Multifabs Ltd (New Building)

Nayapara, Kashimpur, Gazipur.

01st December 2020

1. New Building (G+7)

**Column to be stressed above normal design limit
considering full construction**

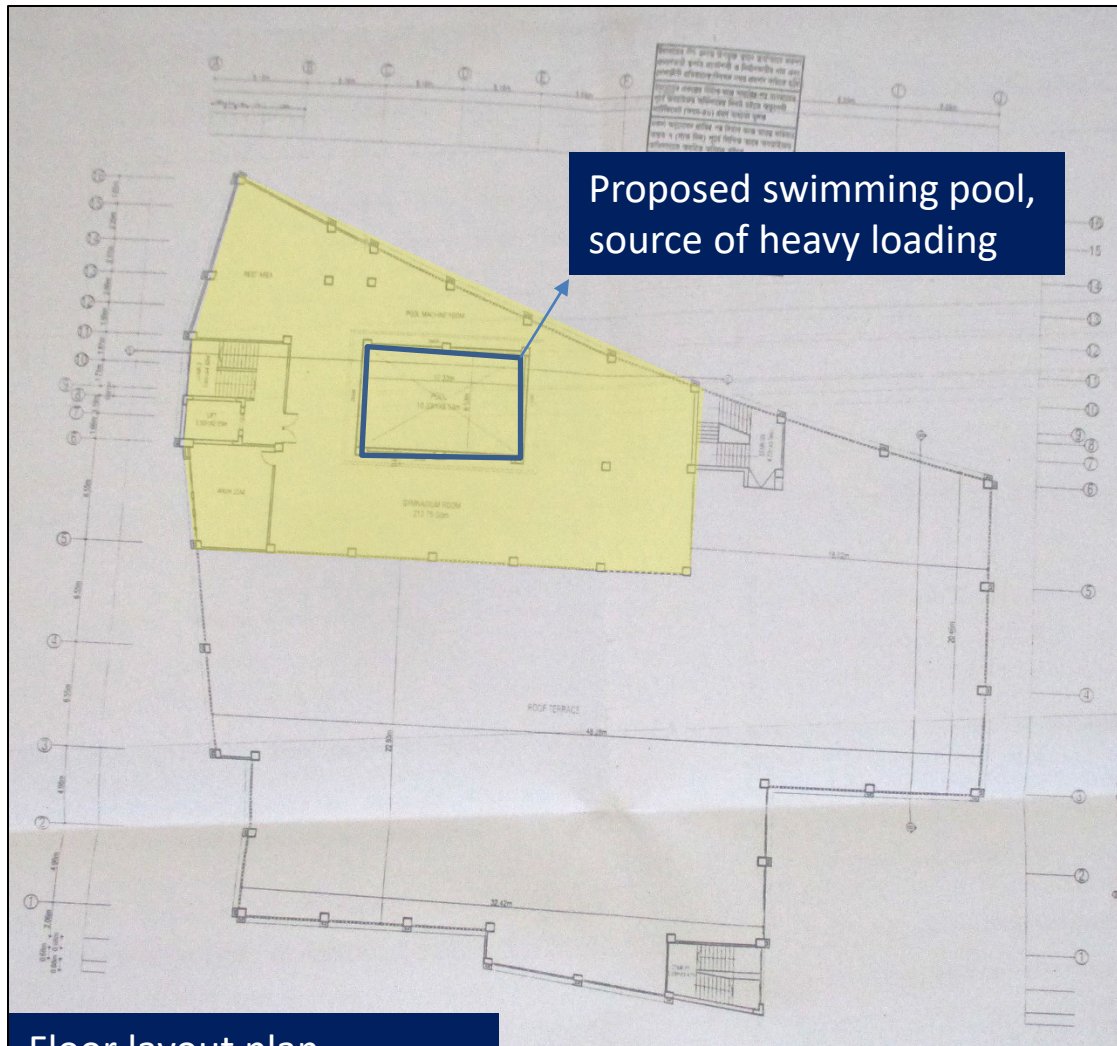
Cursory calculation indicates that the marked columns are stressed above normal design limit considering prepared live load plan and equivalent concrete strength from concrete core test value. Factory engineer is required to review design, load & column stress in the area identified above.

LOAD BEARING CERTIFICATE

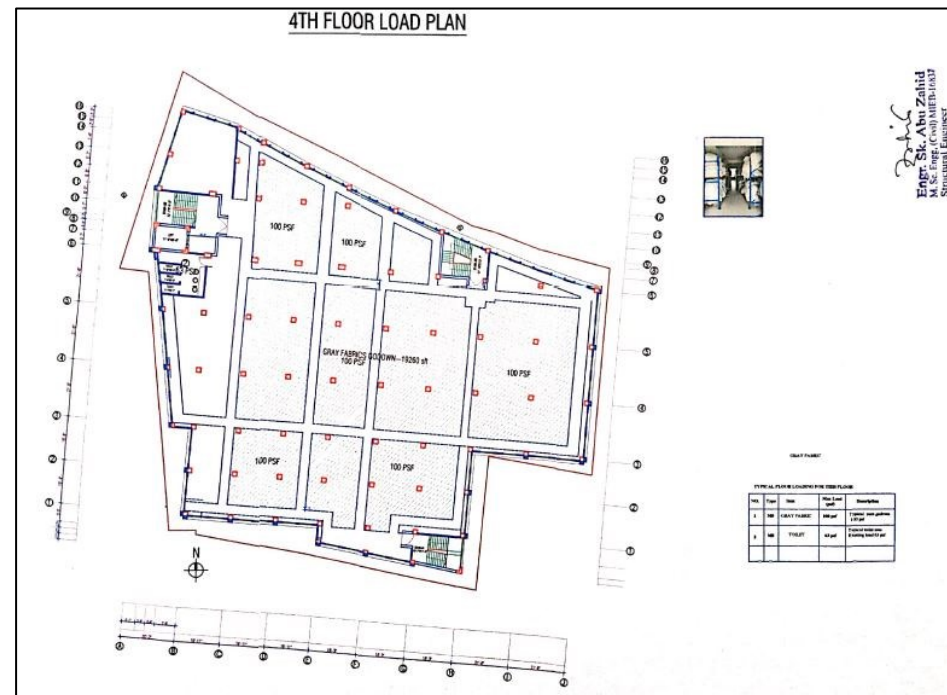
Load bearing certificate do not match with the prepared load plan. Also, equivalent concrete strength do not match with core test values and load bearing certificates.

4th floor load plan

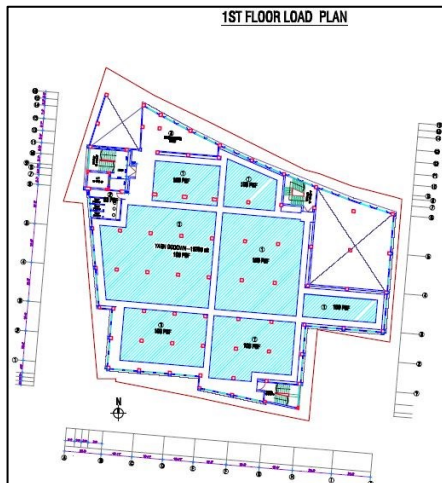
Load plan for 1st to 4th floor. - Floor loading has been shown (100 psf) 4.79 kPa.

Load plan for 5th Floor loading has been shown 3 kPa.

As per BNBC, 6 kPa is required to consider as floor loading for the light storage facilities. During inspection, load plan was found posted considering (100 psf) 4.79 kPa from 1st to 4th floor and 3kpa for 5th floor.

Column susceptible to vehicle impact

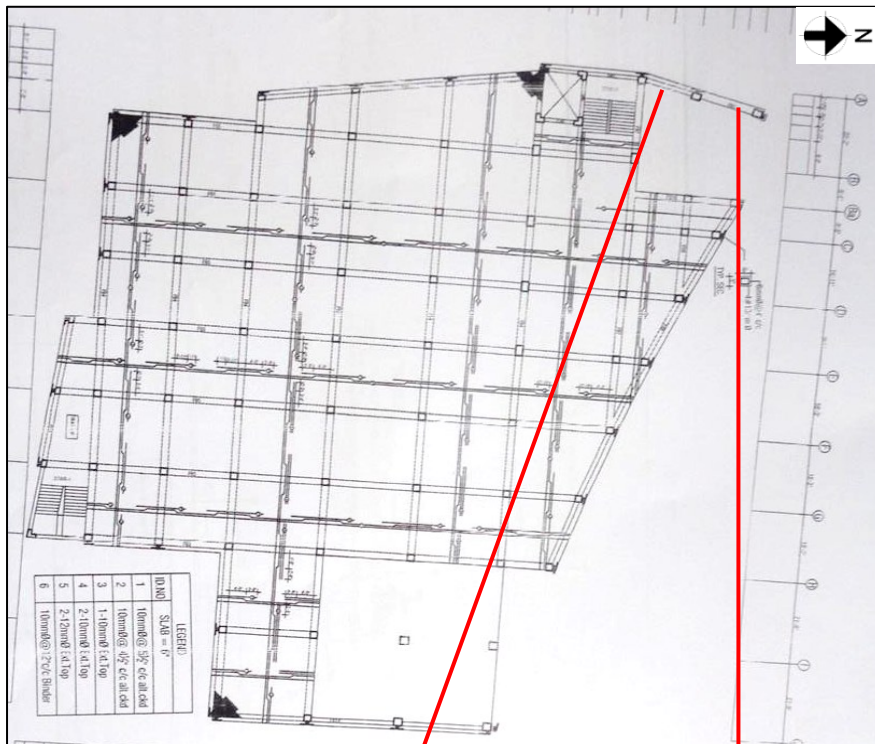
Some of the columns were found adjacent of driveway of parking & loading unloading platform. These column are susceptible to vehicle impact. The factory engineer is required to take necessary measures to prevent the vehicle impact by providing the barrier around the columns.

Partial damaged beam

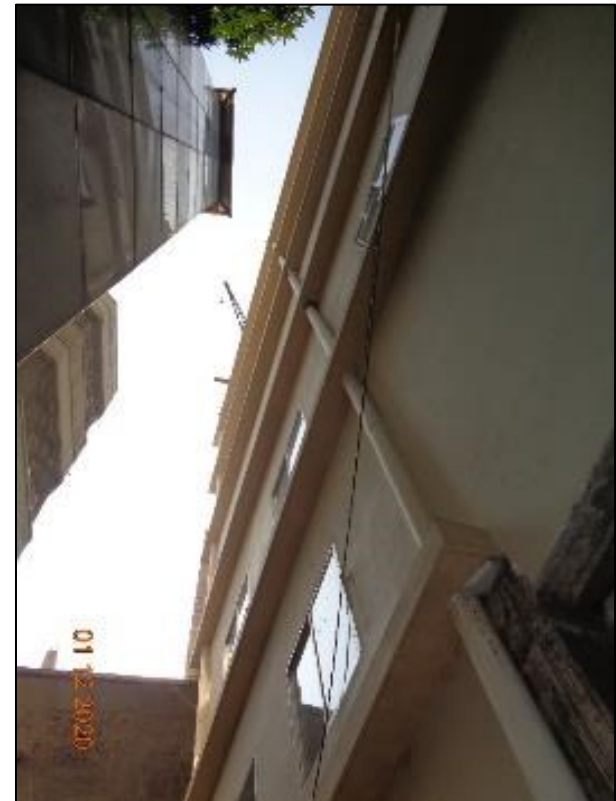
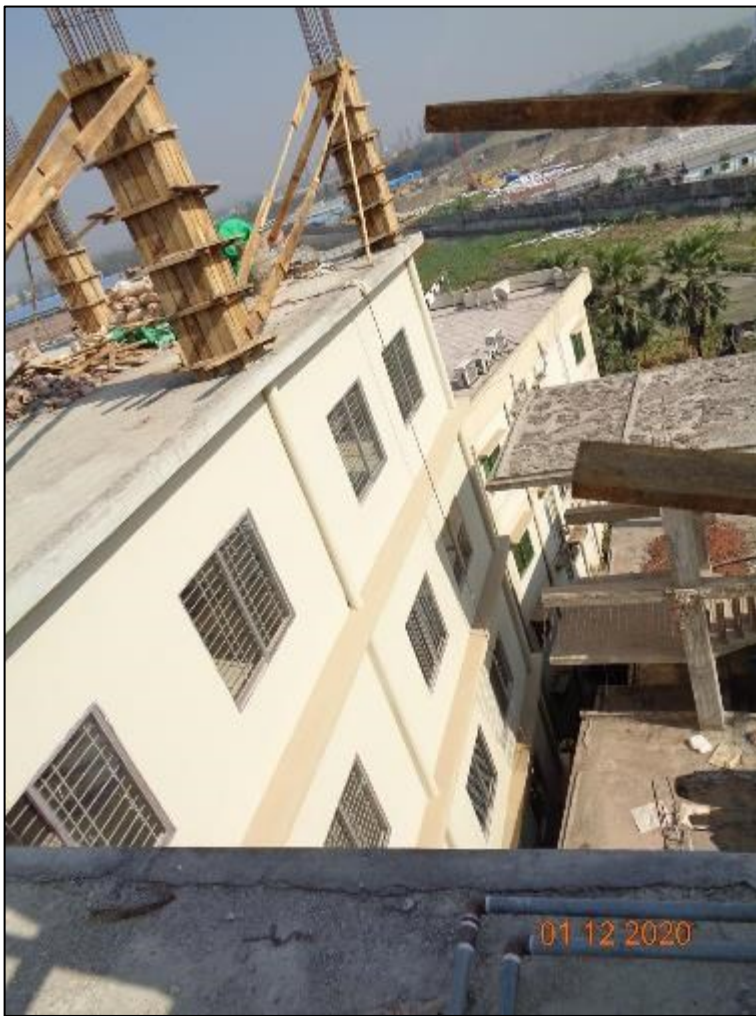
Beams adjacent of driveway of loading unloading platform were found partial damaged due to vehicle impact. The factory engineer is required to investigate the extent of the damage and take necessary measures to repair the damage. Also, the factory engineer is required to take necessary action to prevent the vehicle impact in the beams.
